Form 3160-5 (June 2019)

1. Type of Well Oil Well Gas W	/ell Other	8. Well Name and No	O. ONYX 35 FED COM/742H		
2. Name of Operator EOG RESOURC	CES INCORPORATED		9. API Well No.	30-025-51908	
	BY 2, HOUSTON, TX 77(3b. Phone No. (713) 651-70		10. Field and Pool or	Exploratory Area

Revised Permit Information 08/24/2023:

Well Name: Onyx 35 Fed Com 602H

422' FSL Revised Wellbore KB: 3314'
2193' FEL GL: 3289'

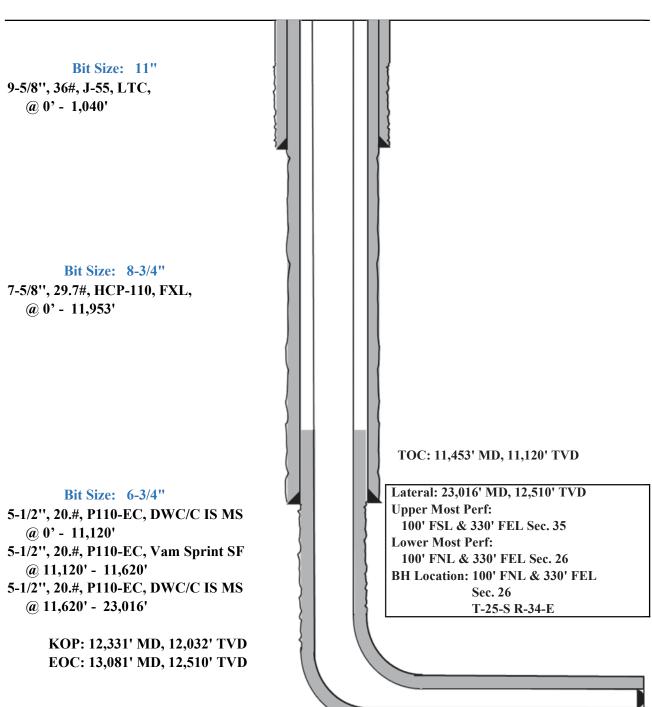
Casing Program:

Hole	Interval MD		Interval TVD		Csg			
Size	From (ft)	To (ft)	From (ft)	To (ft)	OD	Weight	Grade	Conn
11"	0	1,040	0	1,040	9-5/8"	36#	J-55	LTC
8-3/4"	0	11,953	0	11,620	7-5/8"	29.7#	HCP-110	FXL
6-3/4"	0	11,453	0	11,120	5-1/2"	20#	P110-EC	DWC/C IS MS
6-3/4"	11,453	11,953	11,120	11,620	5-1/2"	20#	P110-EC	Vam Sprint SF
6-3/4"	11,953	23,016	11,620	12,510	5-1/2"	20#	P110-EC	DWC/C IS MS

Variance is requested to waive the centralizer requirements for the 7-5/8" casing in the 8-3/4" hole size. An expansion additive will be utilized, in the cement slurry, for the entire length of the 8-3/4" hole interval to maximize cement bond and zonal isolation.

Variance is also requested to waive any centralizer requirements for the 5-1/2" casing in the 6-3/4" hole size. An expansion additive will be utilized, in the cement slurry, for the entire length of the 6-3/4" hole interval to maximize cement bond and zonal isolation.

Variance is also requested to waive the annular clearance requirements for the 5-1/2" casing by 7-5/8" casing annulus to the proposed top of cement.

EOG requests permission to allow deviation from the 0.422" annulus clearance requirement from Onshore Order #2 under the following conditions:

- Annular clearance to meet or exceed 0.422" between intermediate casing ID and production casing coupling only on the first 500' overlap between both casing strings.
- Annular clearance less than 0.422" is acceptable for the production open hole section.

422' FSL Proposed Wellbore KB: 3314' 2193' FEL GL: 3289'

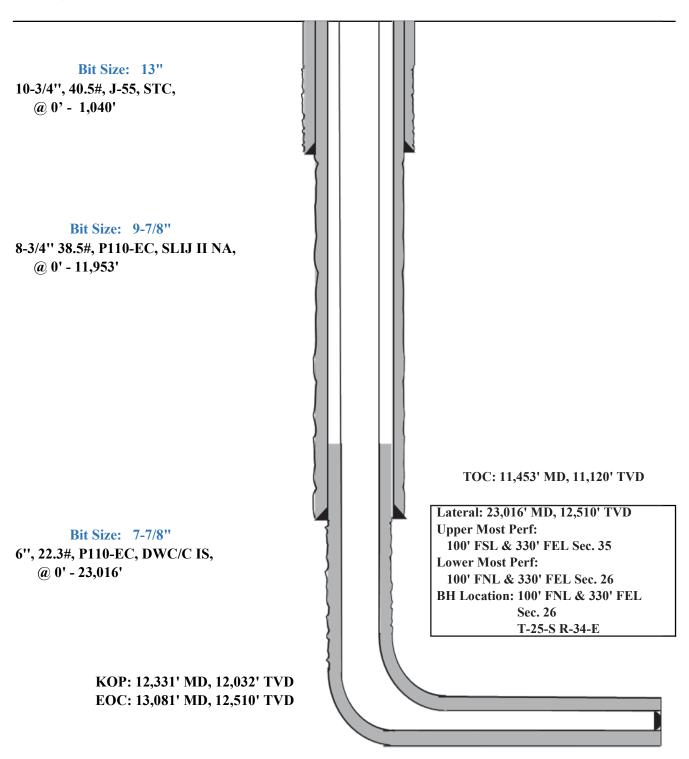
4. CASING PROGRAM

Hole	Interv	al MD	Interva	al TVD	Csg			
Size	From (ft)	To (ft)	From (ft)	To (ft)	OD	Weight	Grade	Conn
13"	0	1,040	0	1,040	10-3/4"	40.5#	J-55	STC
9-7/8"	0	11,953	0	11,620	8-3/4"	38.5#	P110-EC	SLIJ II NA
7-7/8"	0	23,016	0	12,510	6"	22.3#	P110-EC	DWC/C IS

Variance is requested to waive the centralizer requirements for the 8-3/4" casing in the 9-7/8" hole size. An expansion additive will be utilized, in the cement slurry, for the entire length of the 9-7/8" hole interval to maximize cement bond and zonal isolation.

Variance is also requested to waive any centralizer requirements for the 6" casing in the 7-7/8" hole size. An expansion additive will be utilized, in the cement slurry, for the entire length of the 7-7/8" hole interval to maximize cement bond and zonal isolation.

Variance is also requested to waive the annular clearance requirements for the 6" casing by 8-3/4" casing annulus to the proposed top of cement.
